### FERGUSON TOWNSHIP PLANNING COMMISSION REGULAR MEETING AGENDA Tuesday, May 28, 2019 6:00 PM

TO: Planning Commission

FROM: Lindsay K. Schoch, Interim Planning & Zoning Director

SUBJECT: Hummel Subdivision/Subdivision of Tax Parcel 24-7-14E

PROJECT NO. 15102  
 DATE JUNE 6, 2017  
 SCALE 1"=60'  
 SHEET NO. 1 of 2

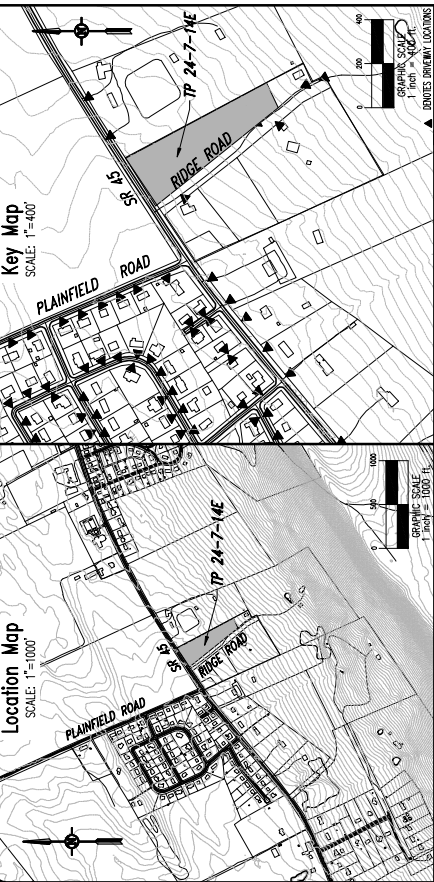
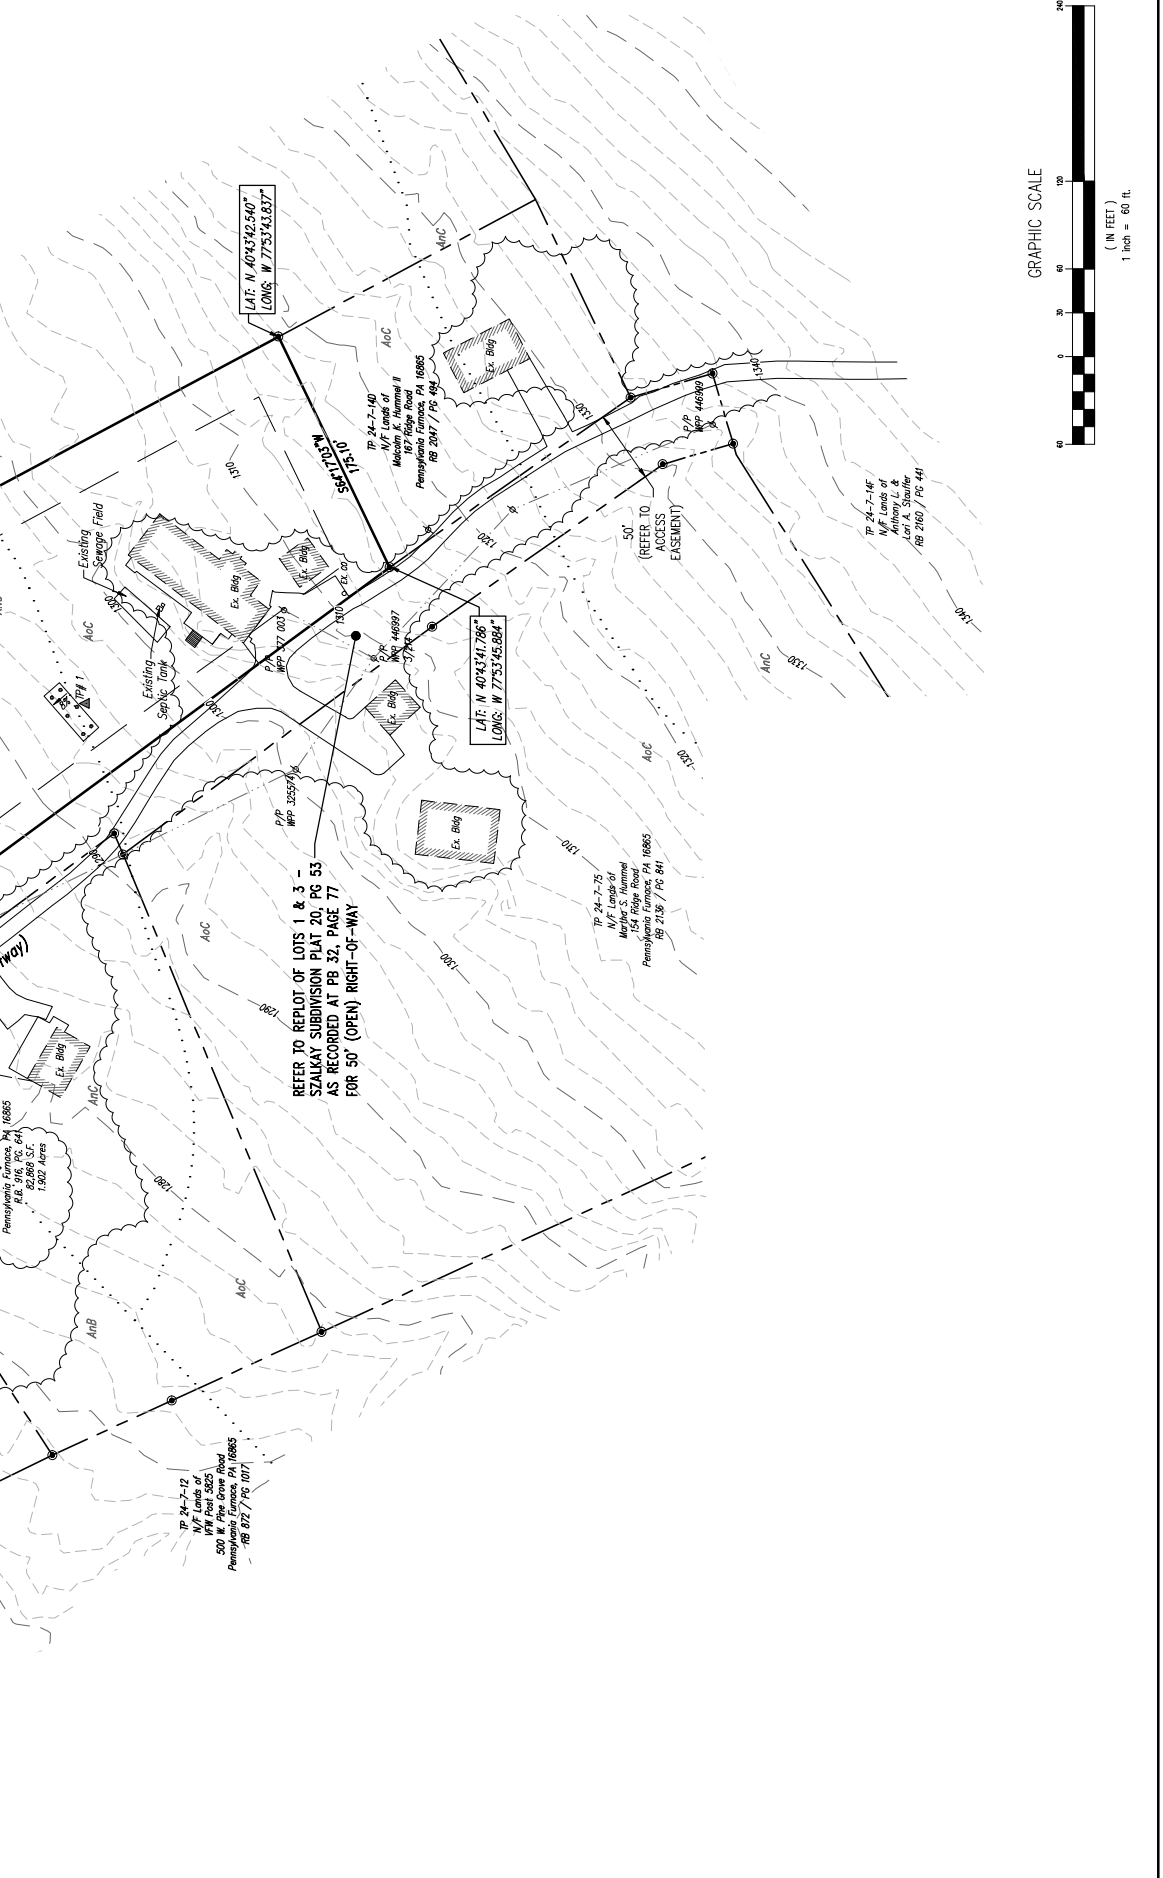
7. The private street agreement that was provided should list both parcels that are owned by Martha S. Hummel. Parcel 24-7-75 (Bk 2136, Pg 841) is missing. (Ch 22, Section 504.2.A.2) Awaiting submission of revised agreement for review. **Comment Stand**

8. The plan proposes an extension of a sanitary sewer main along Ridge Road to serve Lots 1 and 2. The sanitary sewer main extension needs to be designed and included with the plan. Surety will need to be posted for the main extension. (Ch 22, Sec 505.1) The response to this comment does not clarify what is happening. Is this lot being created as a building lot? Note 3 on the plan indicates that UAJA will provide service to the lot. As such, the ordinance requires all newly created lots in the sewer service area connect to the public sewer when approved by the sewer authority. I do not believe it is appropriate to create a salable lot without providing the sanitary sewer required by the ordinance. Not resolved. **Comment Stands**

9. In the RR zoning district, the installation of sidewalks will be determined by the Board of Supervisors. If sidewalks are required, the design of sidewalks needs to be shown on the plan and surety posted for construction. Note 17 needs to be revised. Either the note will indicate the waiver was granted, or the note will be removed, and the sidewalk design added to the plans. A provisional note is not appropriate. (Ch 22-512.1 D) I understand

the Board of Supervisors determined that sidewalks are not required for this plan. *Note 17 just needs to be revised accordingly. **Comment Stands***

10. A fire apparatus access route is required to be 18 feet wide with stabilized mud-free shoulders. Existing Ridge Road is only 10 feet wide. (Ch 22, Sec 506.3.B) I understand that the Board of Supervisors granted a modification from this requirement. A note should be placed on the record plan to summarize the modification approval. **Comment Stands**

11. Fee in lieu of parkland payment as referenced in Note 14 shall be received prior to plan signature. (Ch 22, Sec 513.2.I) I understand that the Board of Supervisors granted a modification from this requirement. *Note 14 should be revised to summarize the modification approval. **Comment Stands***
